Subject: Submittal of the Work Plans for the Plugging and Abandonment of Wells and Boreholes for Fiscal Year 2019, Revision 1

**Cross-Reference of NMED NOD Comments and
Revisions to the Work Plans for the Plugging and Abandonment of Wells and Boreholes for Fiscal Year 2019**

**Response to Notice of Disapproval Work Plans for the
Plugging and Abandonment of Wells and Boreholes for Fiscal Year 2019,
Dated November 2018**

Figure 2.1-1 Locations of alluvial groundwater observation wells in Ancho Canyon

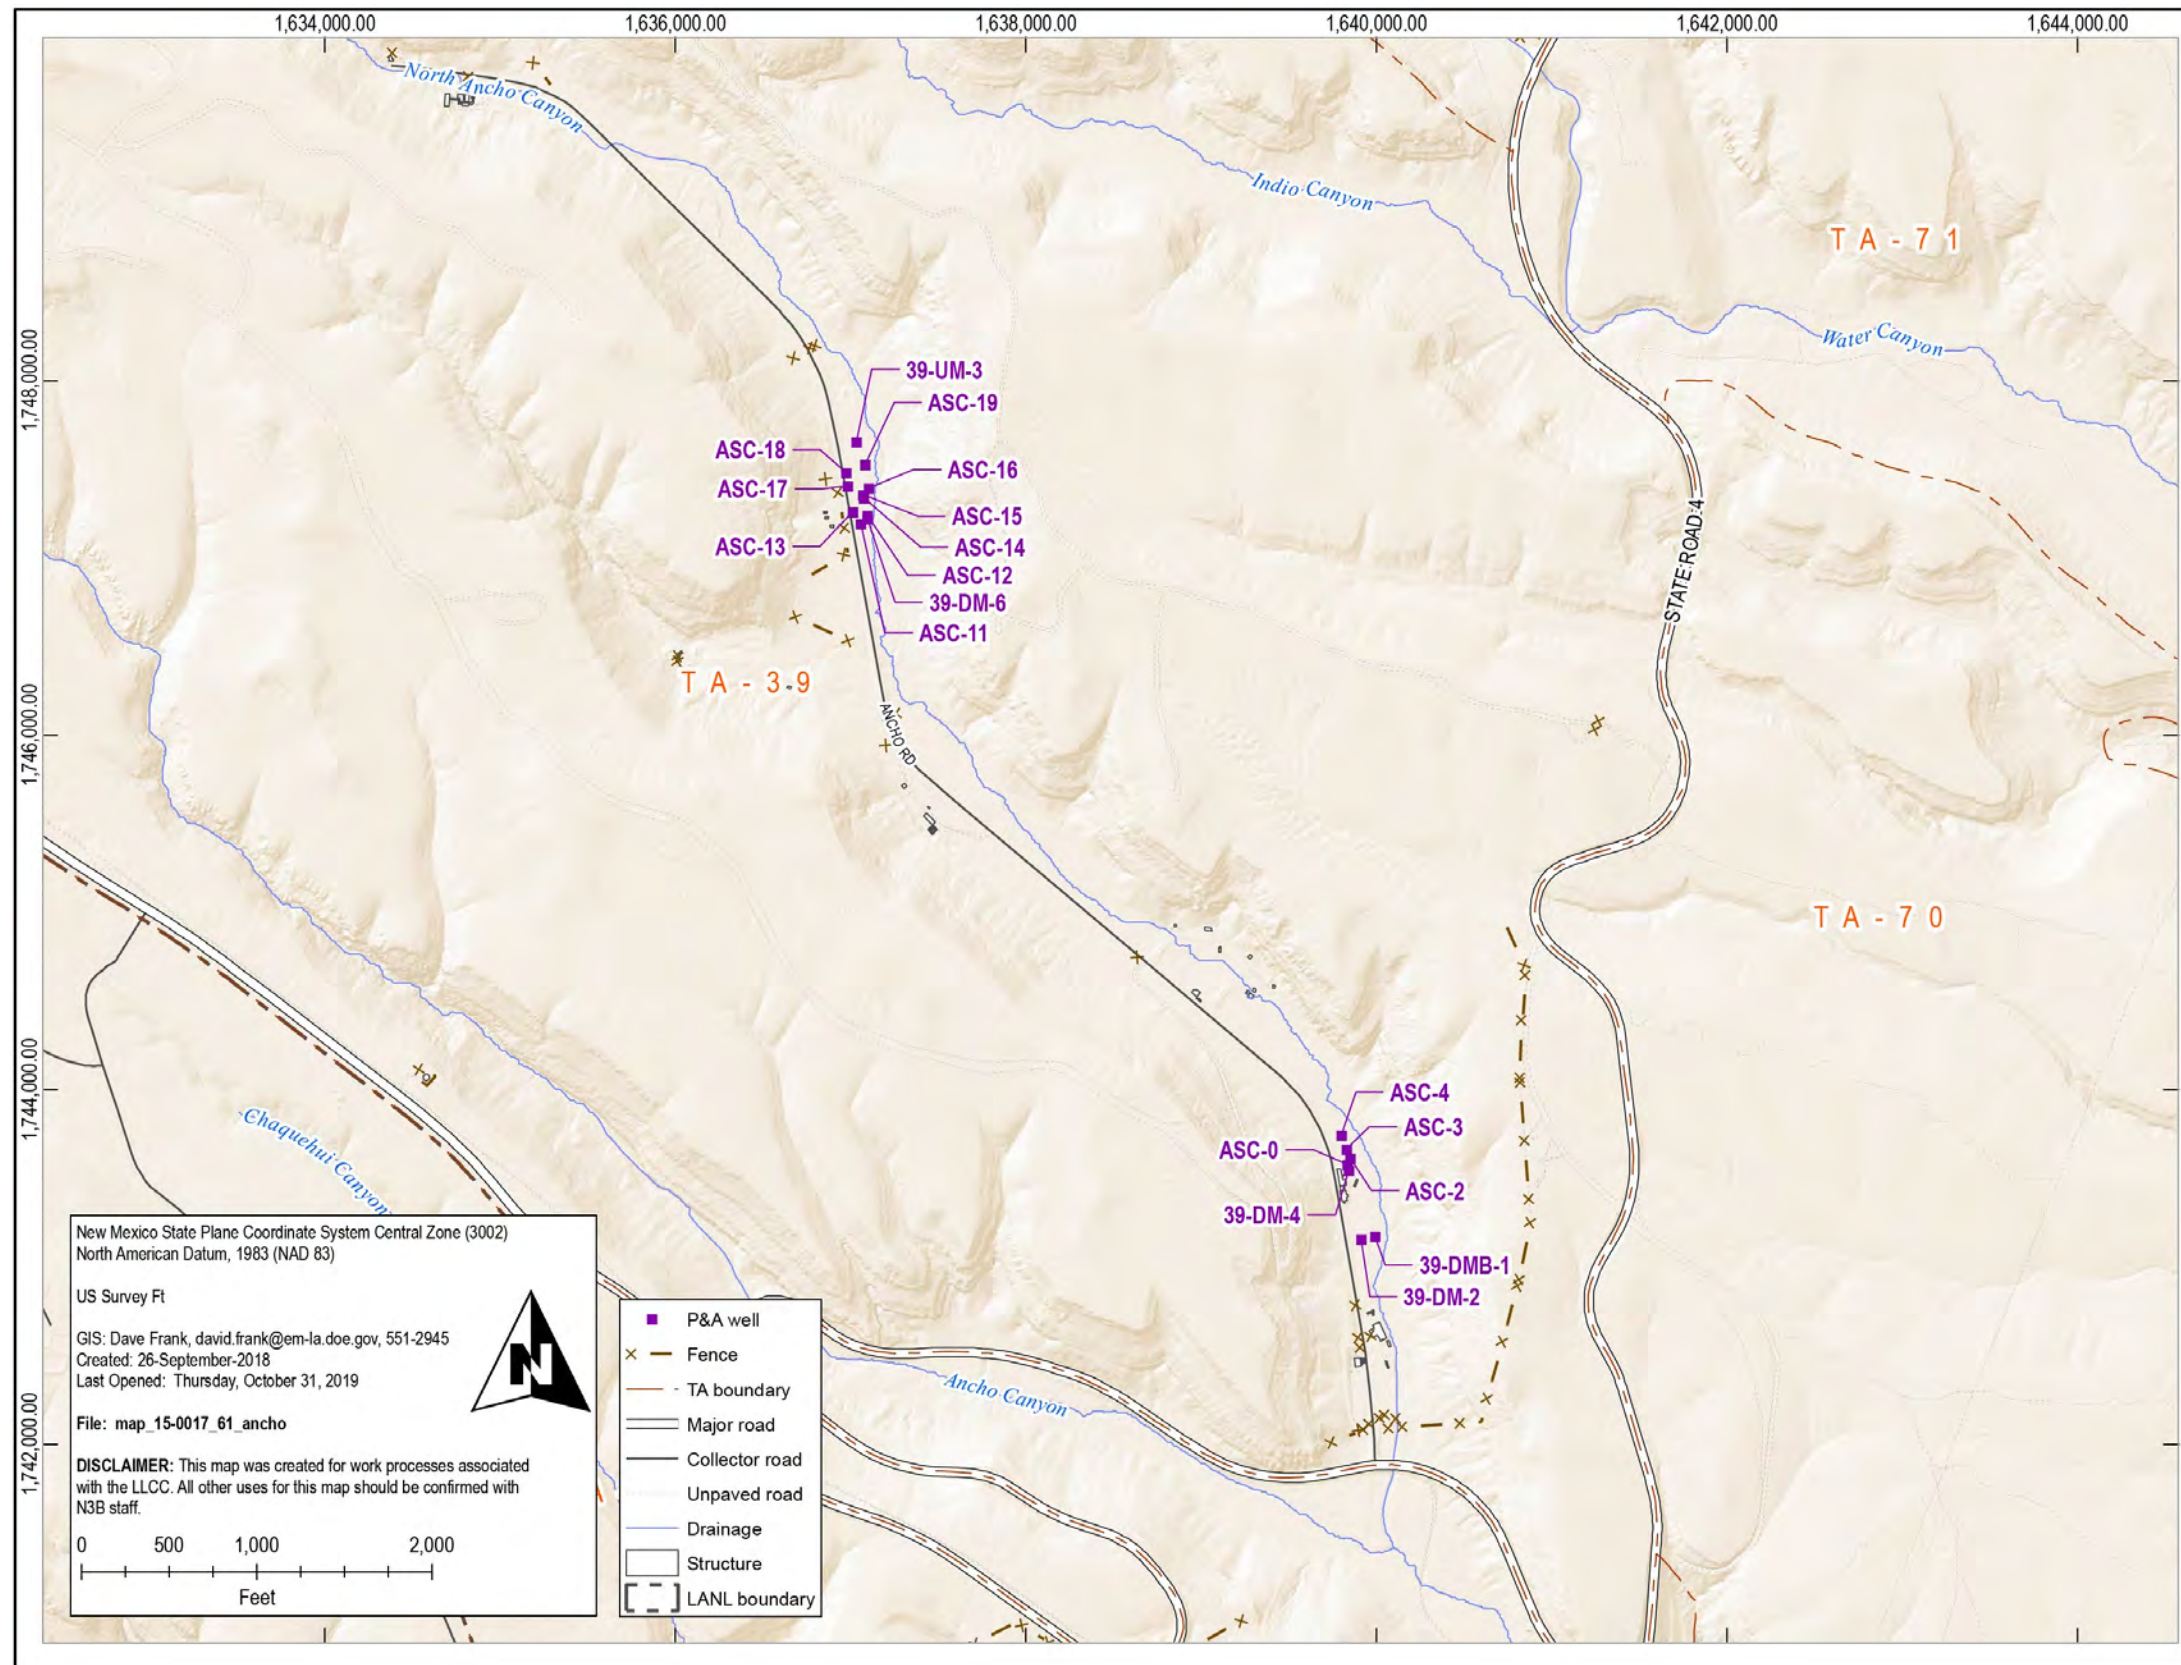
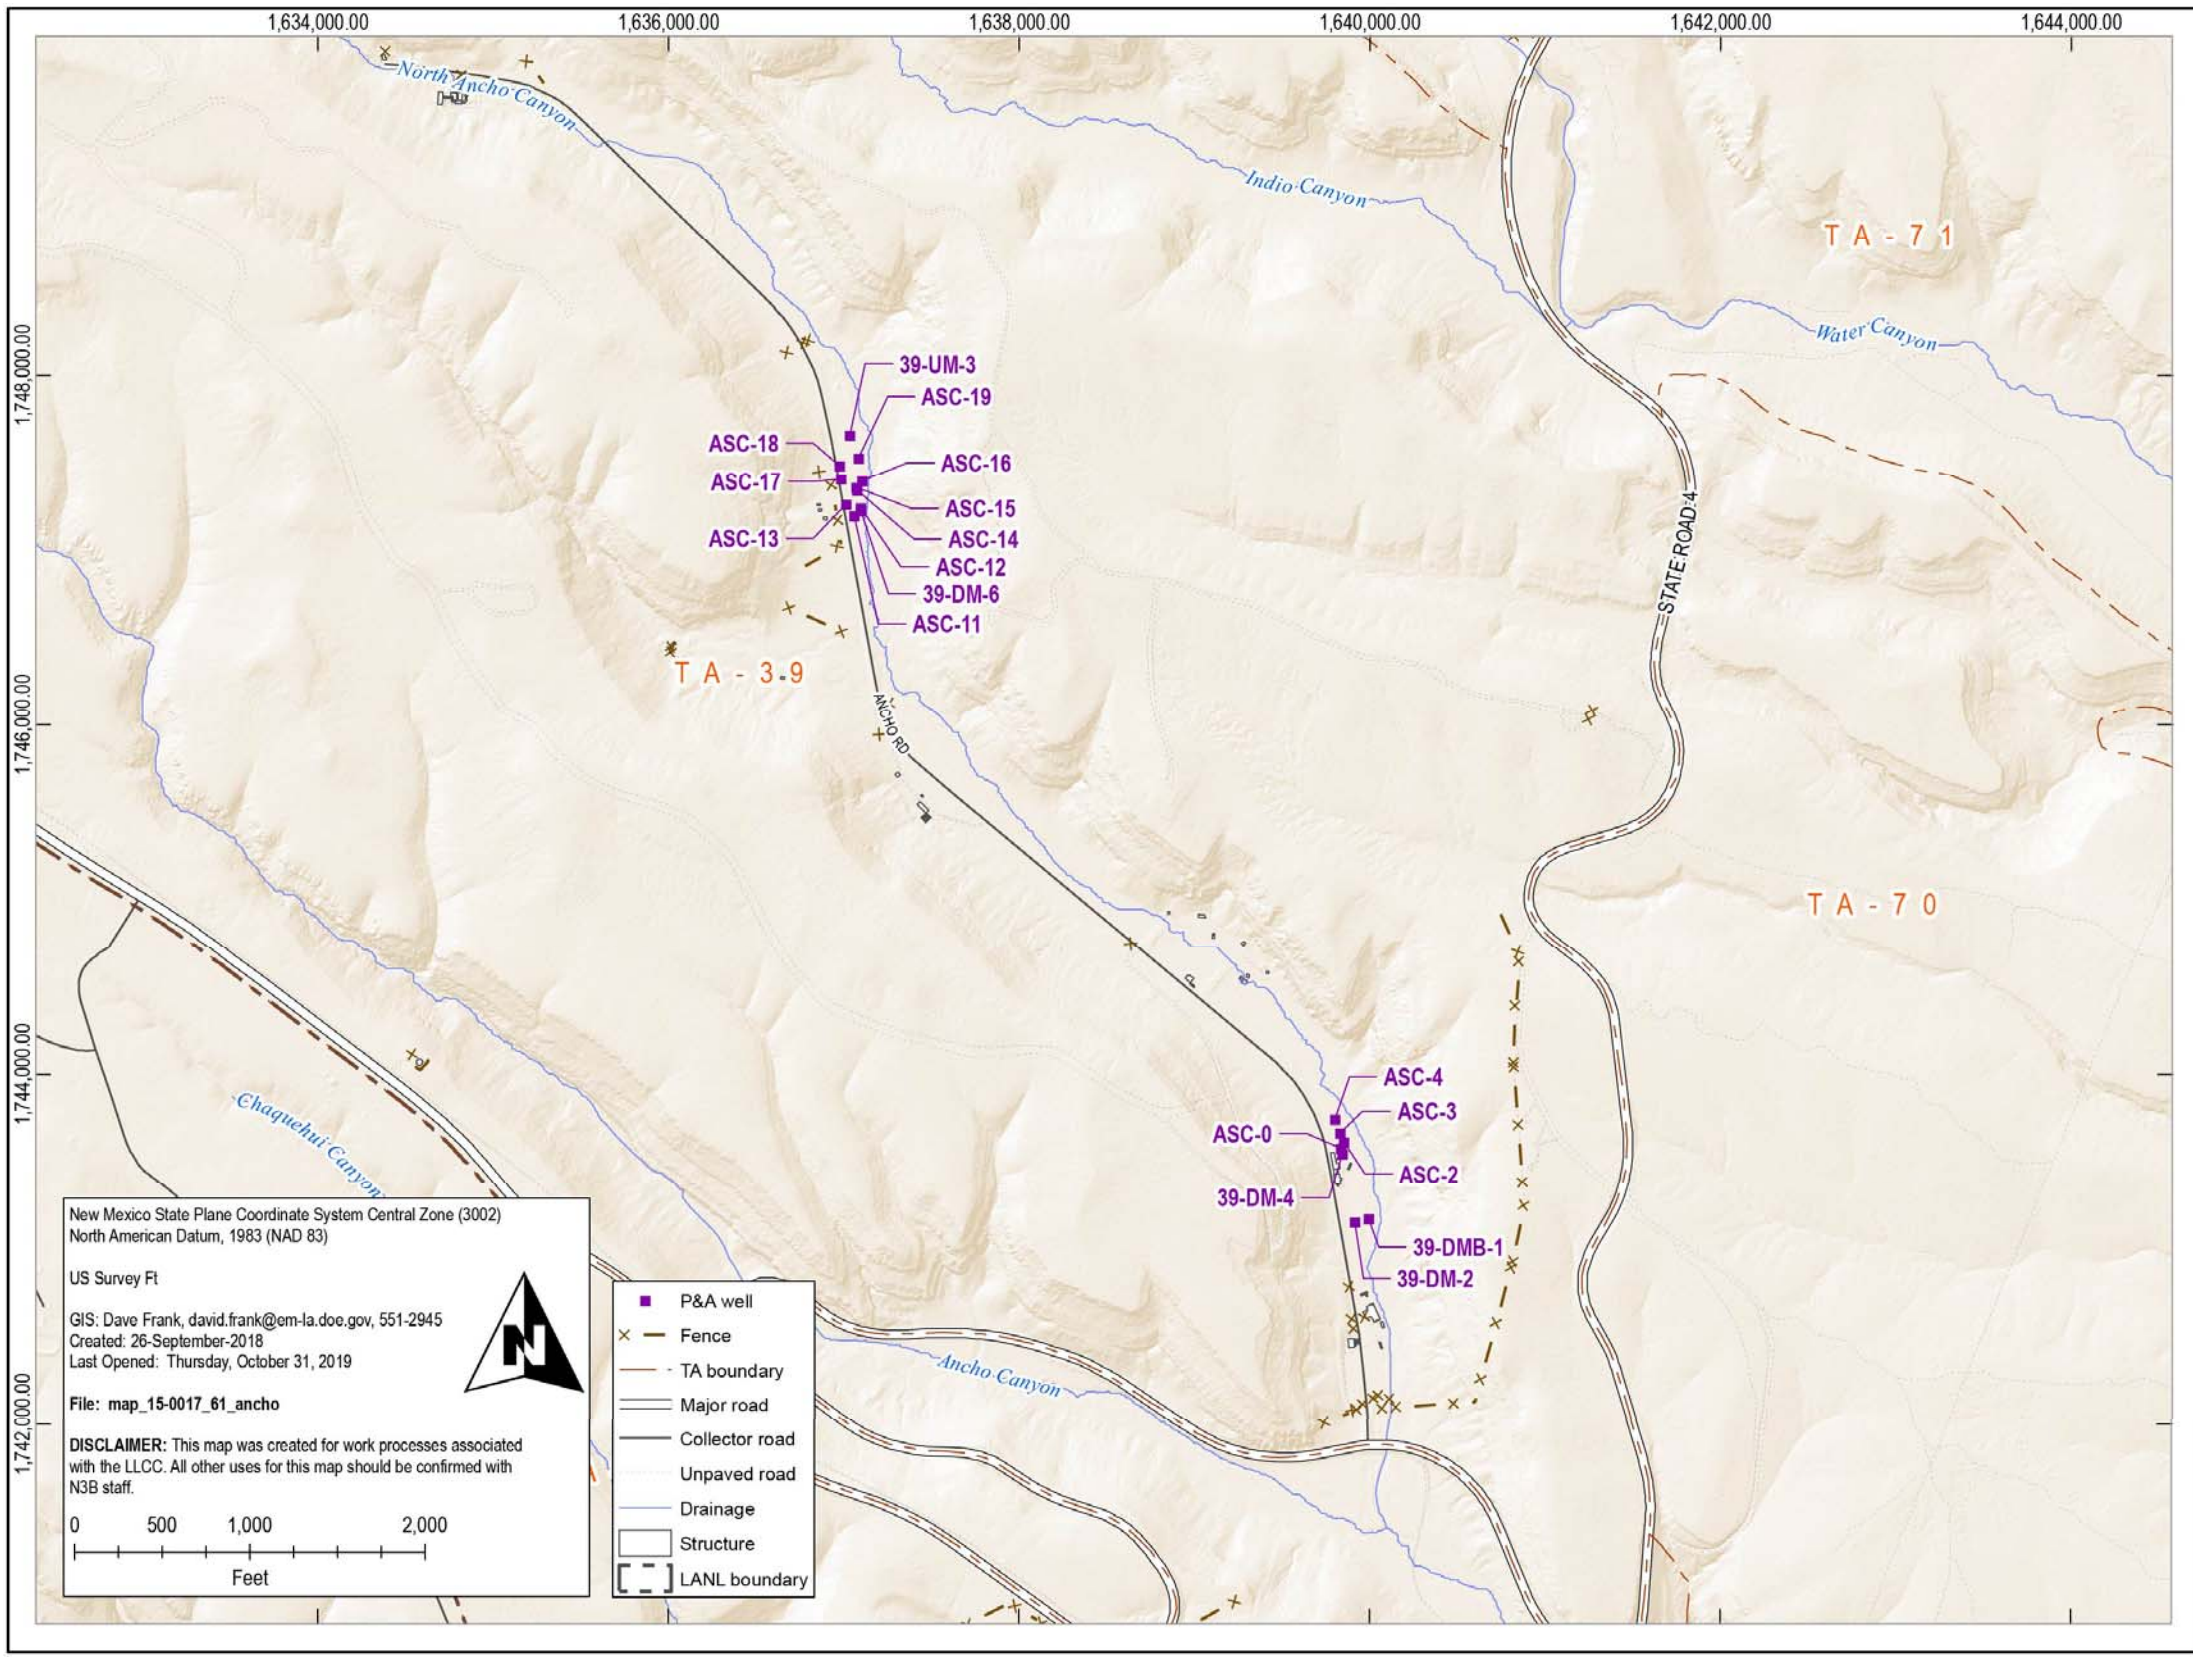
- 1. Section 3.1, Work Plan to Plug and Abandon Alluvial Boreholes and Groundwater Observation Wells in Ancho Canyon, page 4:**

1. Language has been added to section 2.1 to address when the monitoring wells in Ancho canyon were last monitored for the presence of groundwater.
